MARK-UP OF SECTION 96 INCLUSIONS

16.07.2015 - 29.07.2016	A	DEVELOPMENT APPLICATION ISSUE SECTION 96 ISSUE	Morris Goding Elisa Moechar Phone: 9692 8000 Email: elisa@mgac.com.au	MDA Australia Damon Bissell Phone: 400 444 410 Email: damon@mda-aust.com.au	Chris Medland Phone: 9437 4611 Email: chris@medlandmetropolis.com.au	Brian Clarke Phone: 9437 4611 Email: brian@wilkinsonmurray.com.au	Tony Henslip Phone: 9211 7777 Email: tony@tmplg.com.au	Glenn Dixon Phone: 9332 3601 Email: glenn@360.net.au	WENONA SCHOOL 176 Walker Street, North Sydney NSW 2060 Phone: 9409 4406 Email: hmckenzie@wenona.nsw.edu.au	WENONA PROJECT ARCHEMEDES 255-265 Miller Street, North Sydney NSW 2060 PROJECT NO : 14010	Tonkin Zulaikha Greer Architects 117 Reservoir Street ABN: 4600272349 P: (02) 9215 4900 F: (02) 9215 4901 EMAIL: matilda@tztg.com.au WEB www.tztg.com.au	LEVEL 6 PLAN SCALES 1:100 @A1 PHASE SECTION 96 DRAWING NO A-1008 REVISION A	ABN, AVDB, JH, MW, SB, SD, CW CHECKED PT

16.07.2015 - 29.07.2016	A	DEVELOPMENT APPLICATION ISSUE SECTION 96 ISSUE	Do not scale off drawings. Use figured dimensions only. Report any discrepancies to the architect. These designs, plans, specifications and the copyright therein a

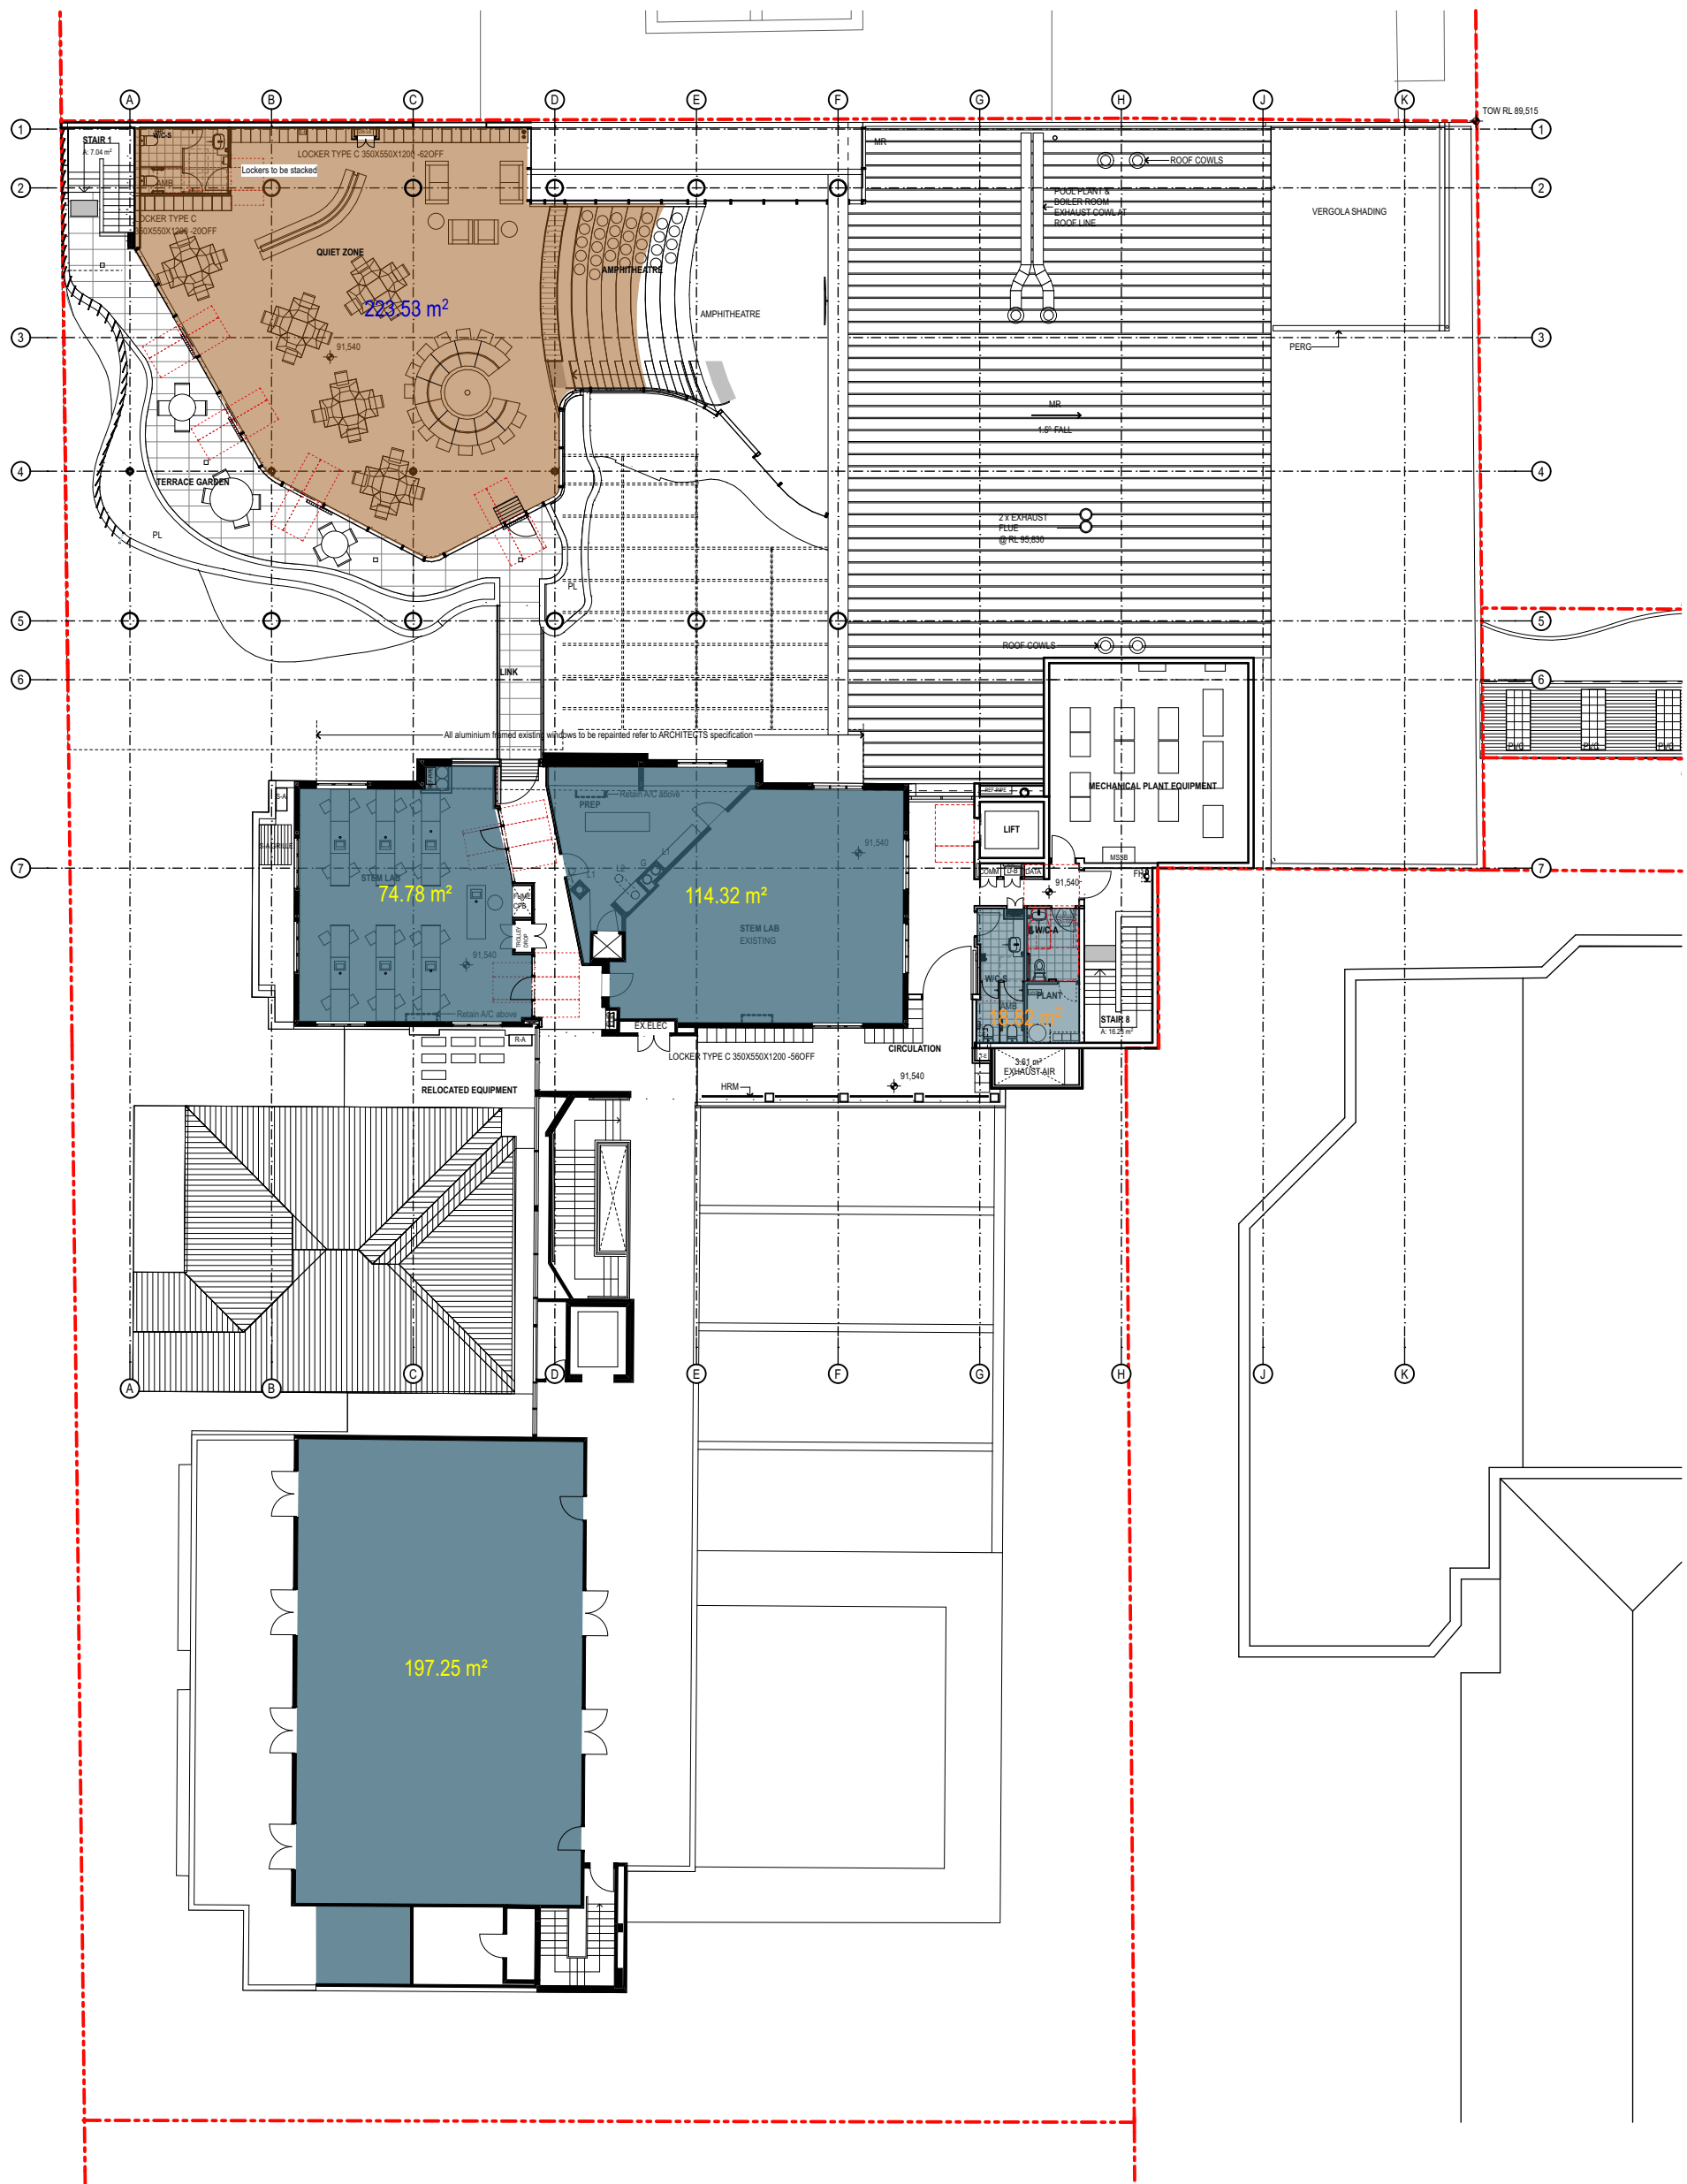
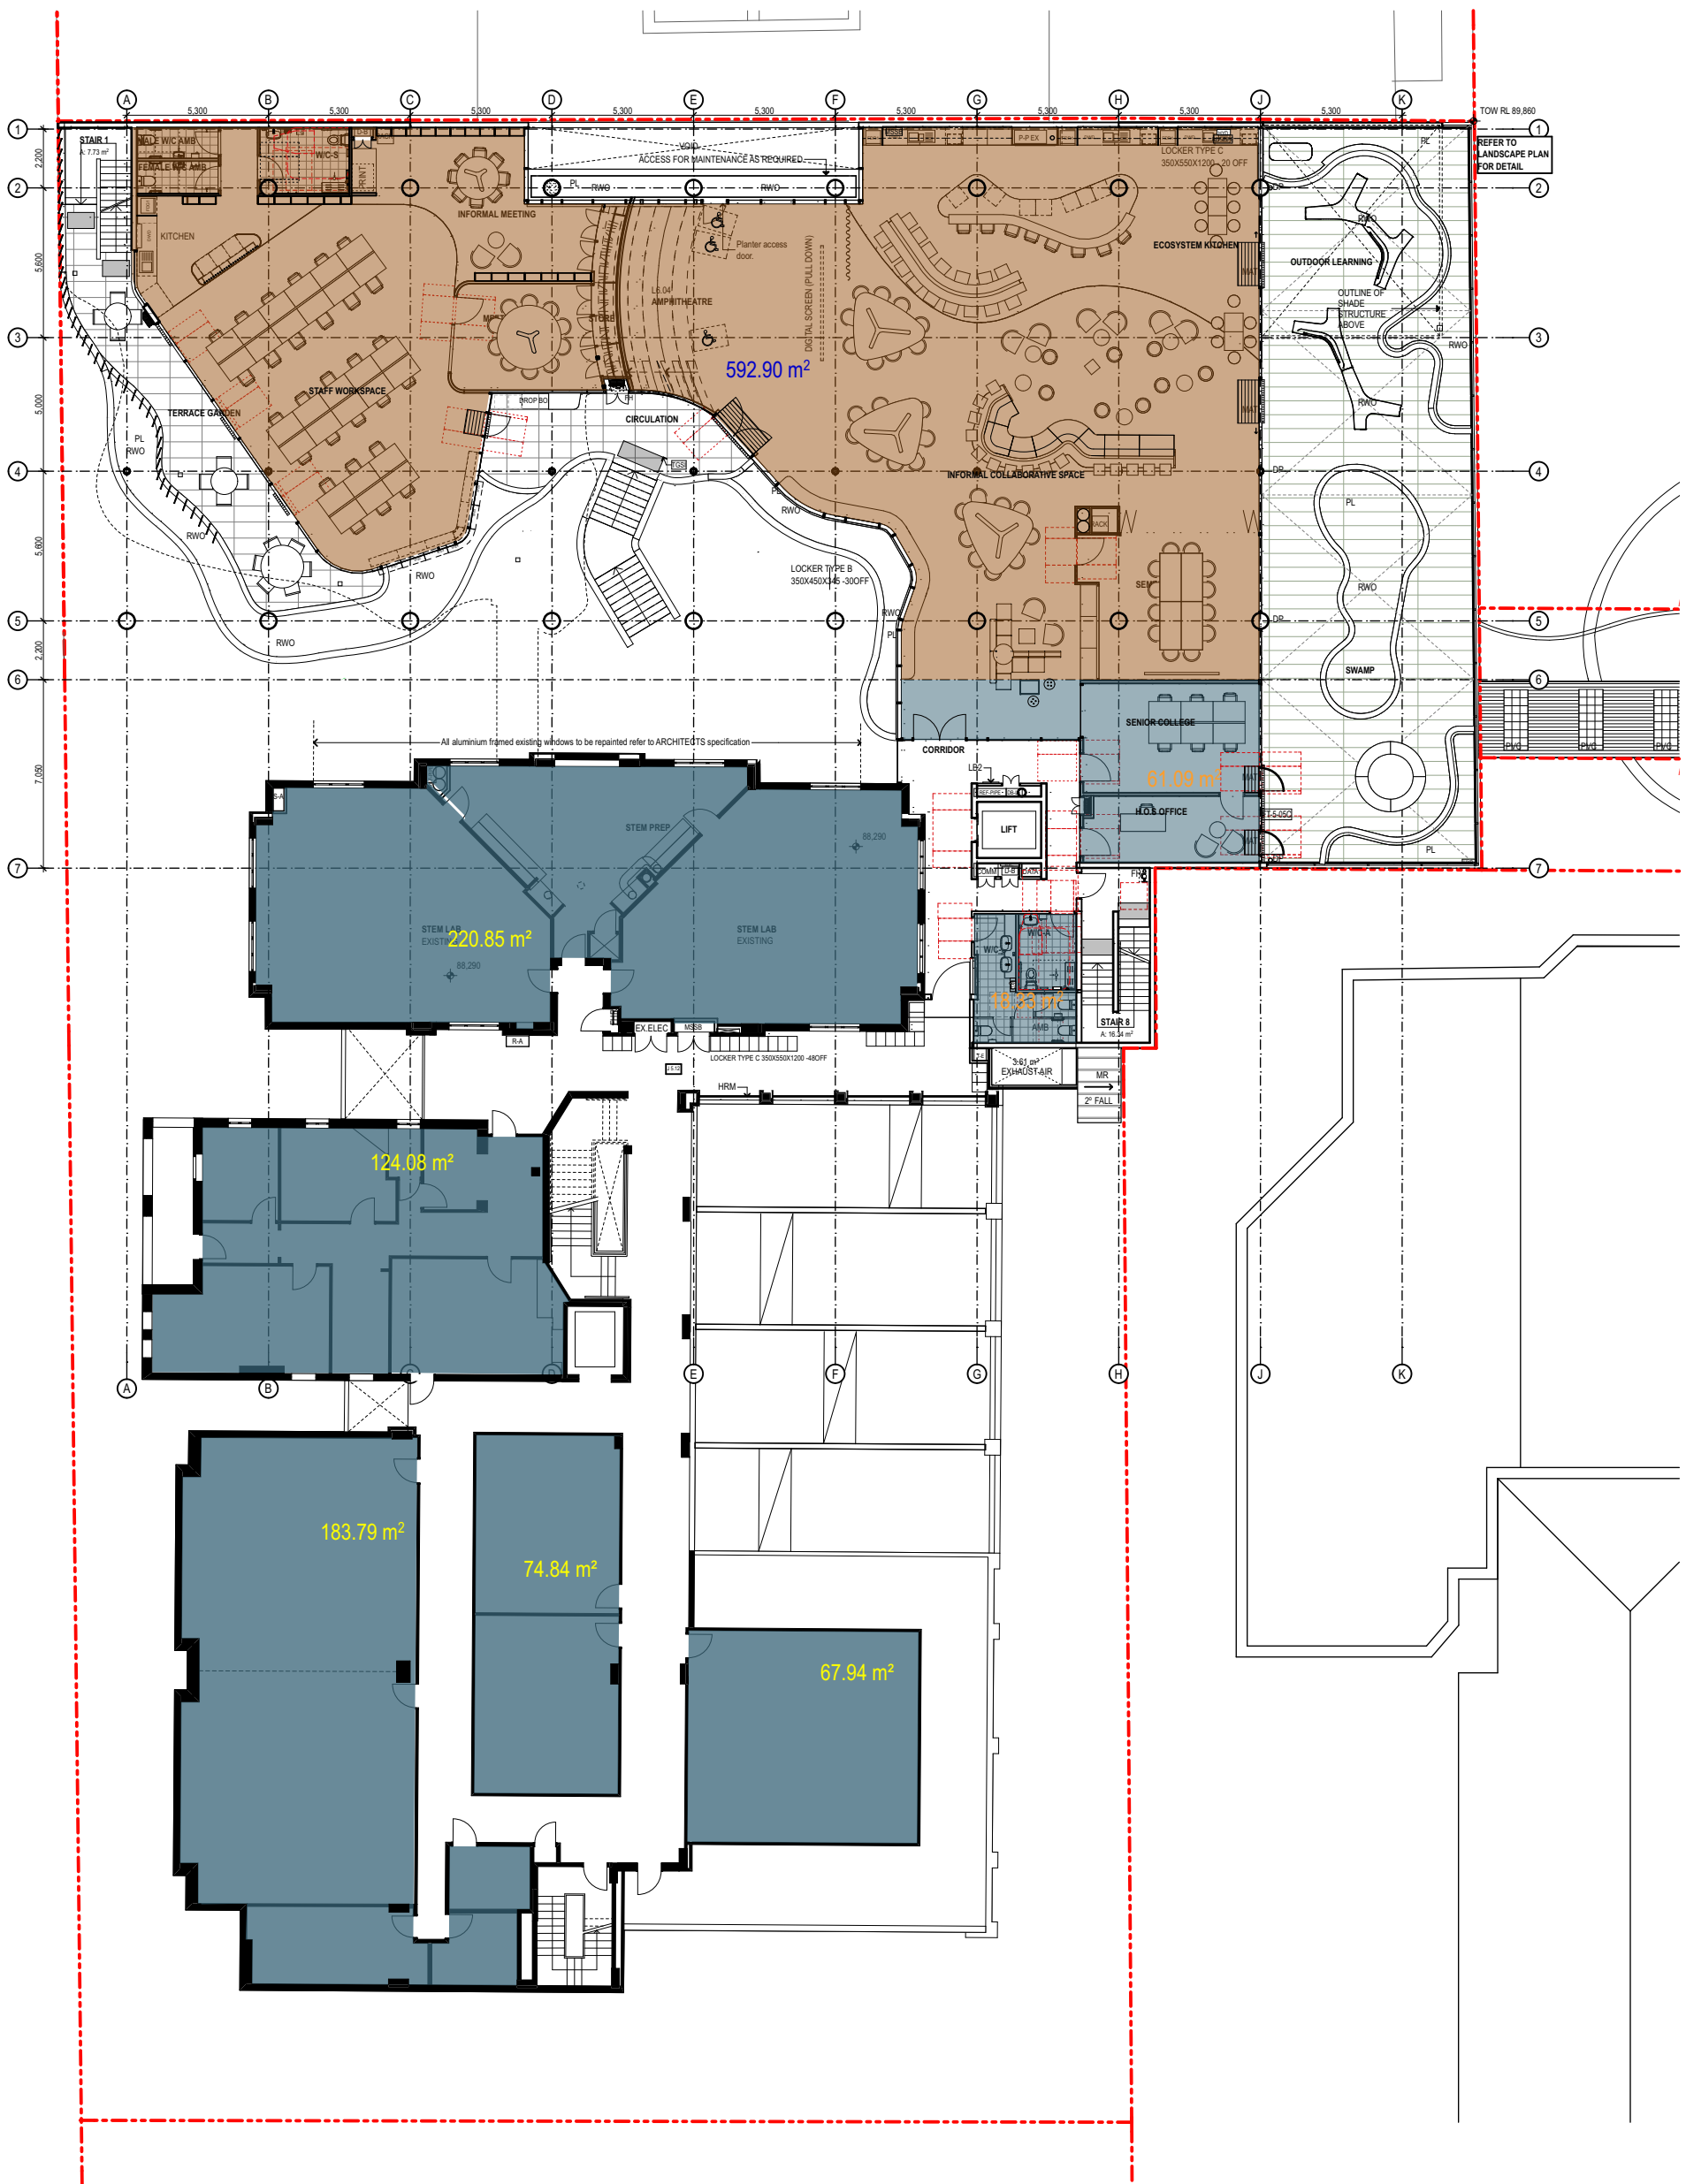
6 GFA/FSR Modification
